Document 009113.1.1 - Addendum No. 1

DeKalb County, Illinois
Courthouse Addition
Bid Package 1

PSA-Dewberry No.: 50038973

REVISE LINTEL DETAIL		Date: 01-04-11	Sketch No.: SSK-17
Project: DEKALB COUNTY COURTHOUSE ADDITION		Scale: AS INDICATED	Issued As: ADD.#1 -BP#1
		Project No.: 50038973	Drawing Reference No.: 7/S-313

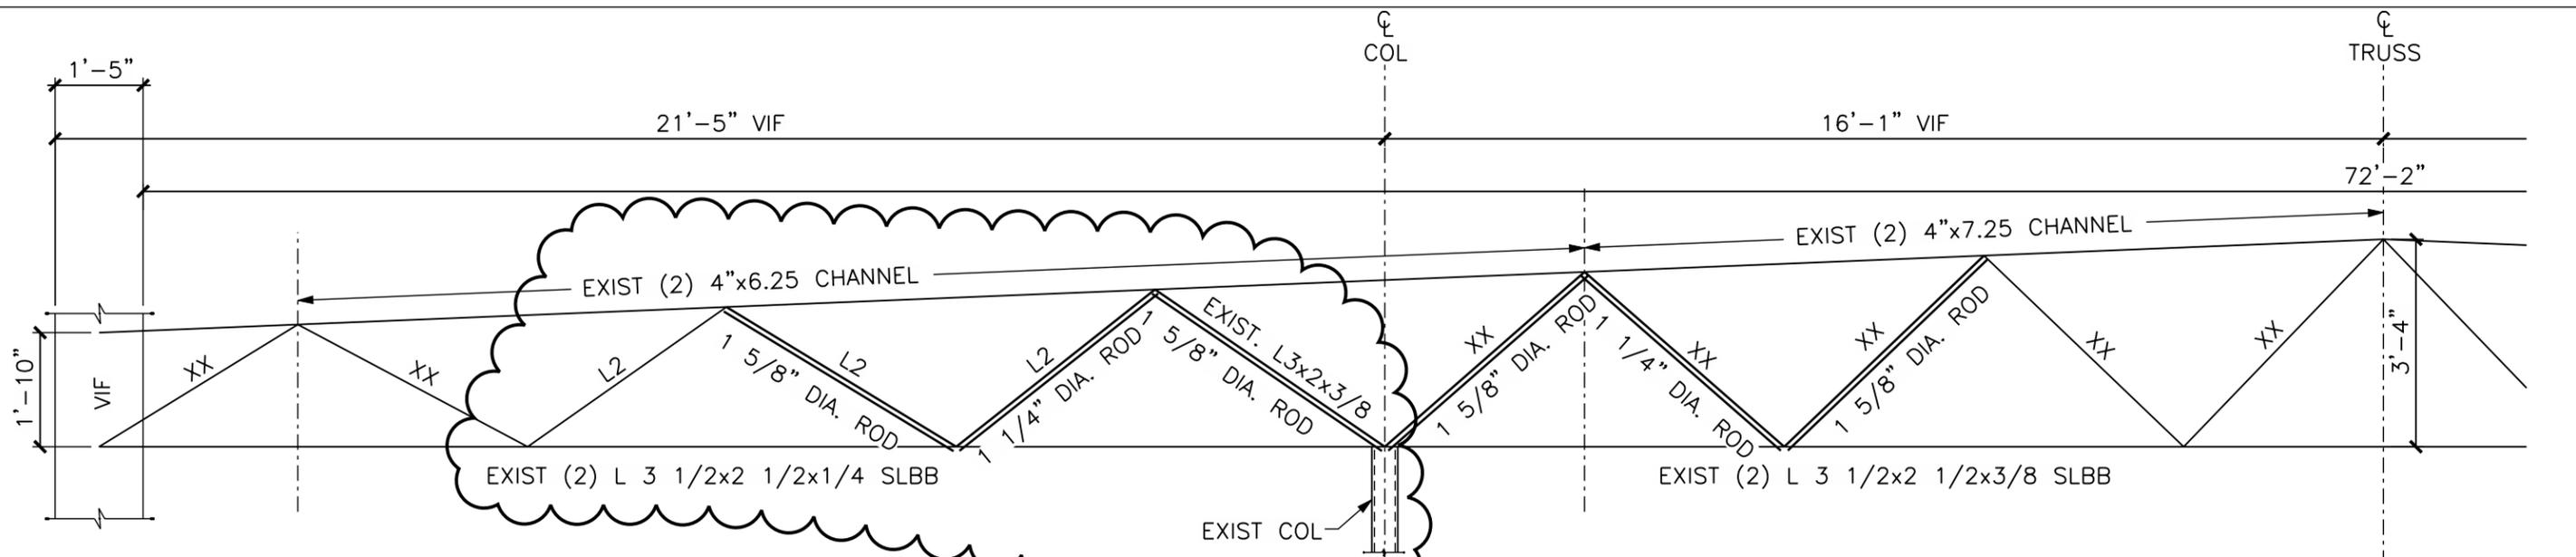
1. REVISE lintel configuration in detail 1 as shown in the attached sketch SSK-15.
2. REVISE concrete curb configuration in detail 5 as shown in the attached sketch SSK-16.
3. REVISE lintel configuration in detail 7 as shown in the attached sketch SSK-17.
4. REVISE general note for details 2, 5 and 6 to read as follows: “PROVIDE

PSA Dewberry PSA DEWBERRY 25 S. GROVE AVE., SUITE 500 ELGIN, IL 60120 (847) 695 5840 (847) 742 4571 Fax	REVISE TRUSS REINFORCING MEMBERS	Date: 01-04-11	Issued As: ADD. #1 -BP#1	Sketch No.: SSK-18
	Project: DEKALB COUNTY COURTHOUSE ADDITION	Scale: AS INDICATED	Project No.: 50038973

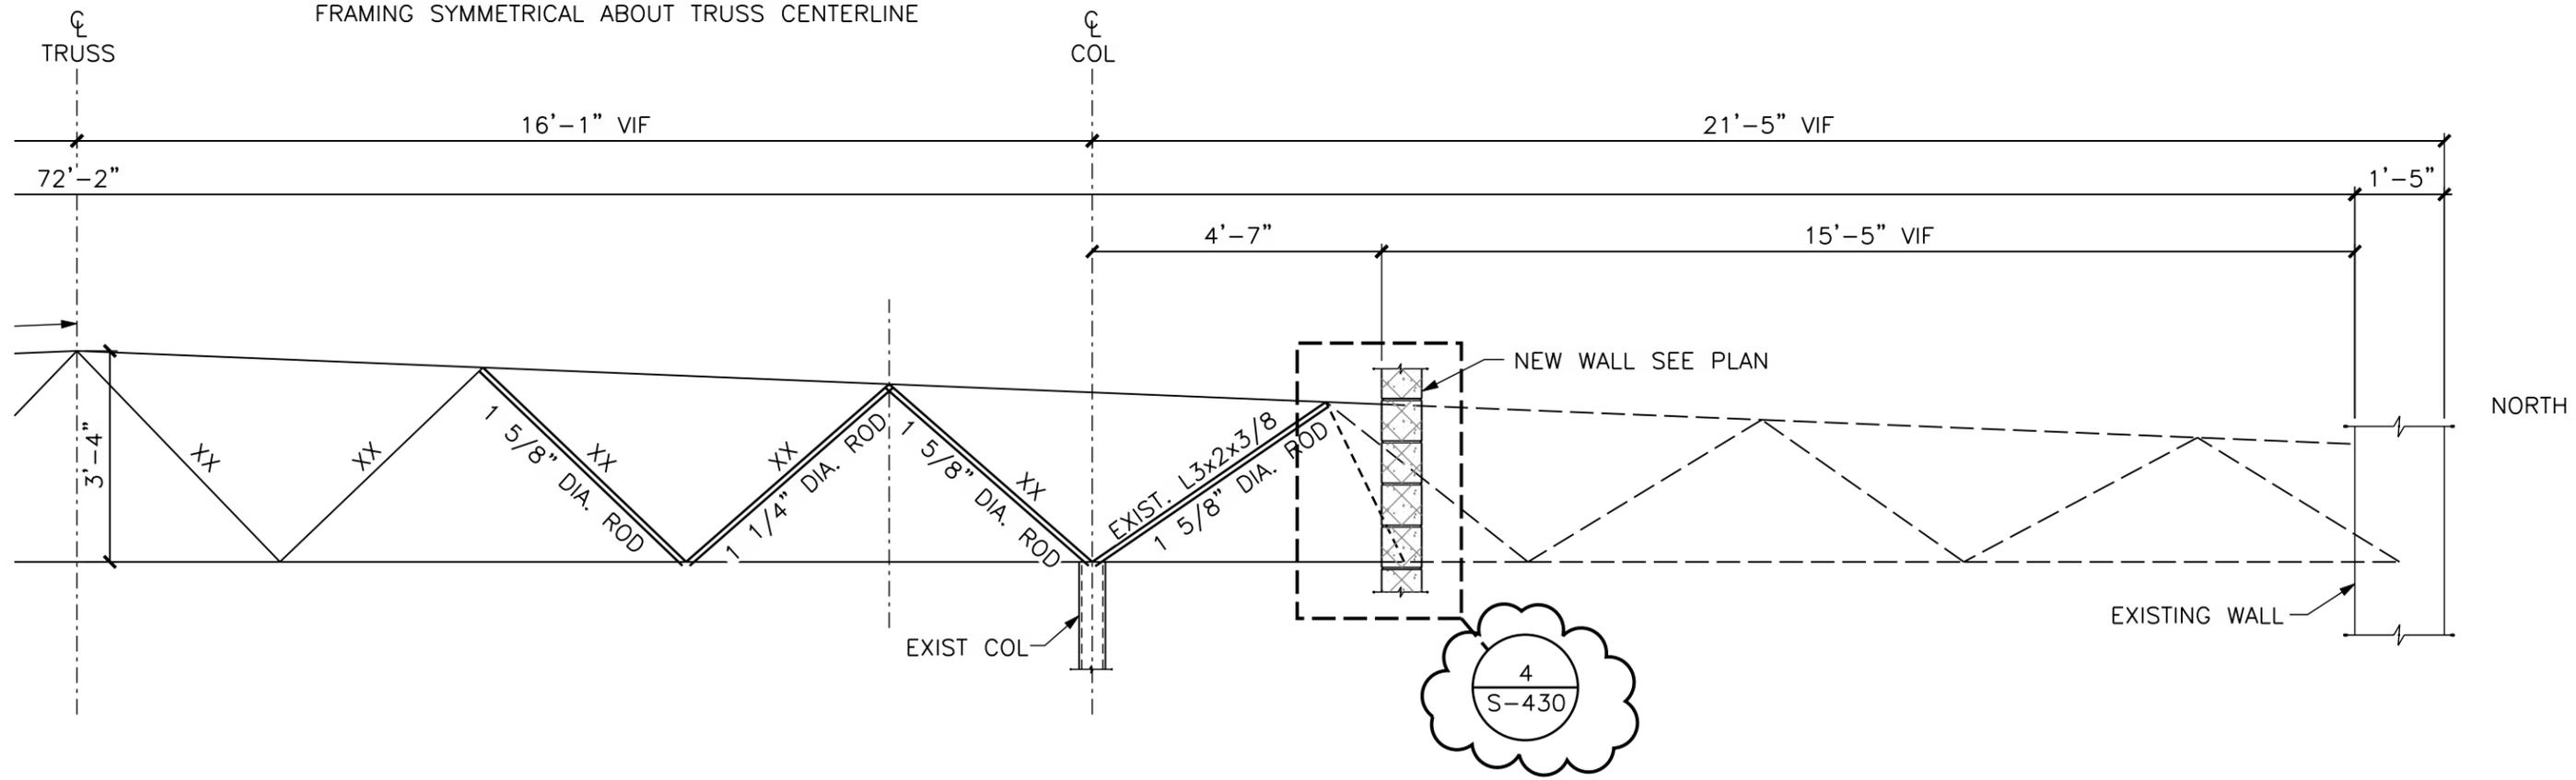
- L. Sheet No. S-420 – Structural Bracing Elevations and Details
 - 1. CLARIFY force indicated in HSS tube members for braces 1 thru 3 is to be considered as both a compressive and tensile force.
- M. Sheet No. S-430 – Existing Truss Modifications and Details
 - 1. REVISE truss members in detail 2 as shown in the attached sketch SSK-18.
 - 2. ADD weld information for new truss members in detail 4 as shown in the attached sketch SSK-19.

L2 =EXIST L2 1/4x2 1/4x1/8
 == EXISTING TO BE REINFORCED W/ A36 ROD AS INDICATED
 — EXISTING FRAMING TO REMAIN
 - - - EXISTING FRAMING TO BE DEMOLISHED
 FRAMING SYMMETRICAL ABOUT TRUSS CENTERLINE
